REMARKS

This application has been critically reviewed and editorially amended to correct some obvious errors. There is no change in meaning or scope of the specification or of the claims.

FIG. 1 Red marked copy

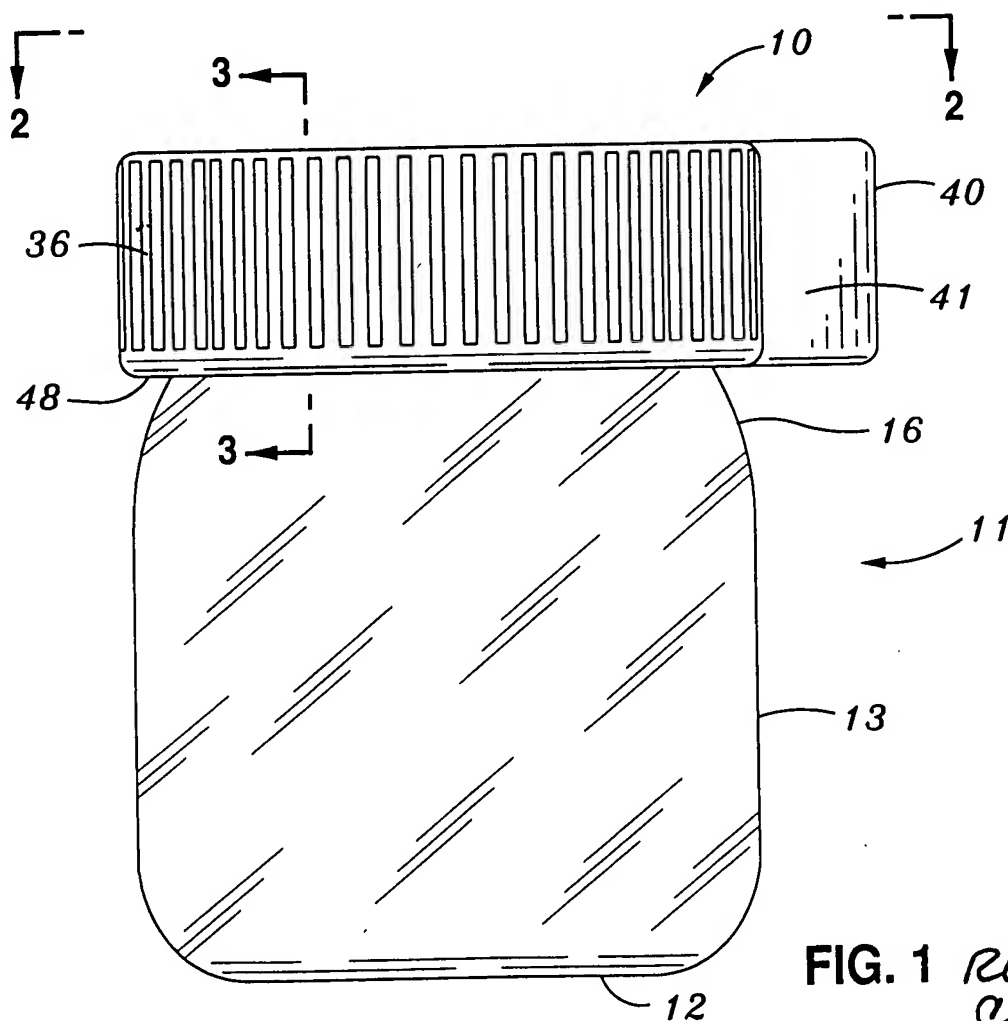
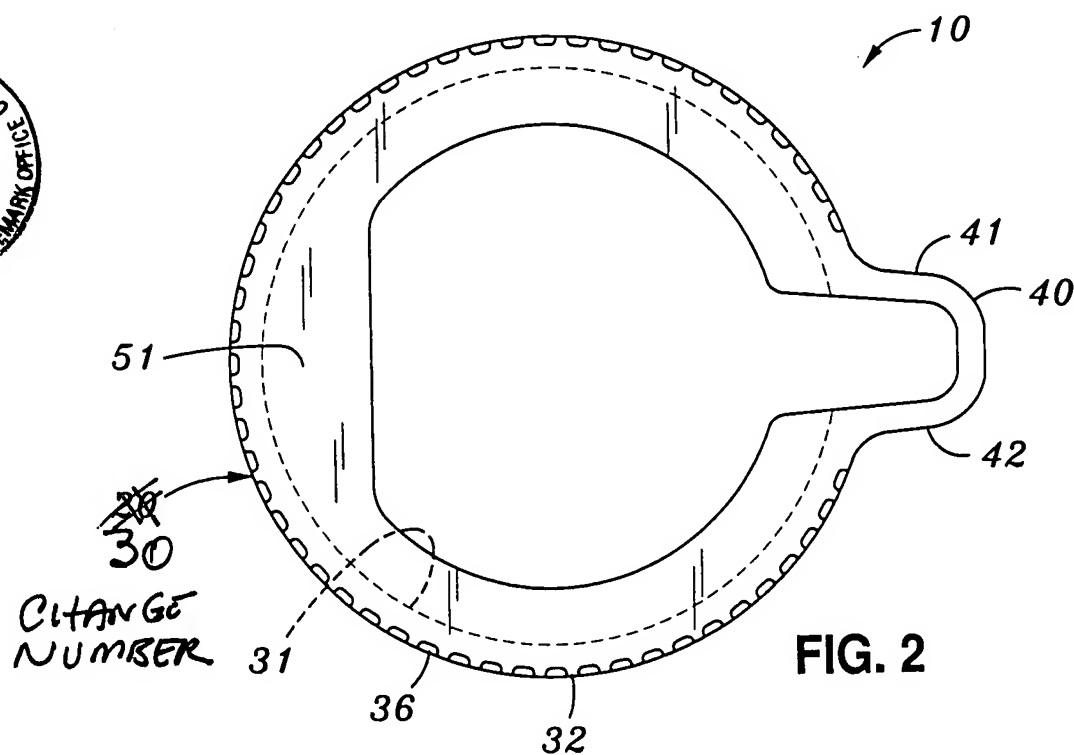
In the drawings, reference number 20 in Figs. 1 and 5 has been corrected to "30". Substitute sheets are enclosed, and a set marked in red is enclosed. The Examiner is requested to approve these changes.

Claim 1 has been amended to add the feature of stops 50 (Fig. 1).

FIG. 3

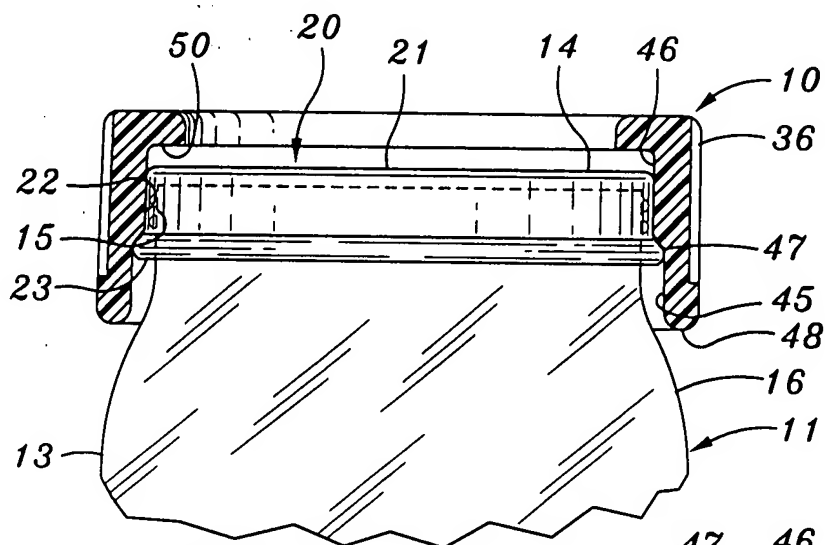
As to numbers 45,46, it is submitted that they are correct. 46 is the smaller diameter (Fig. 3). Fig. 4 is a bottom view, where it shows 46 is the smaller. This should attend to the objection to the drawings and to the specification in this regard.

FIG. 4

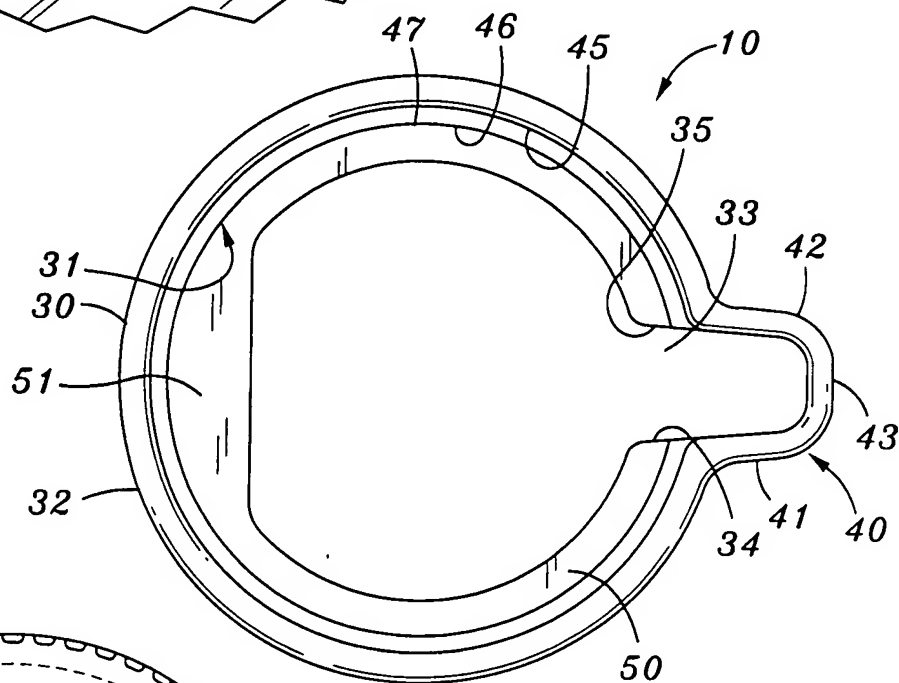
Claim 5 depends from claim 1 and is amended to include the arch-like shoulder 40 (Fig. 4).

FIG. 5

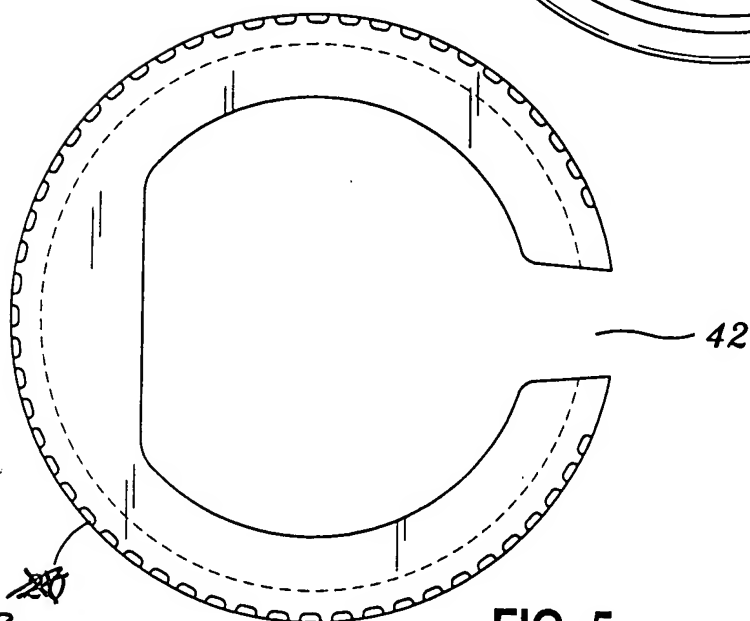
30
CHANGE
NUMBER
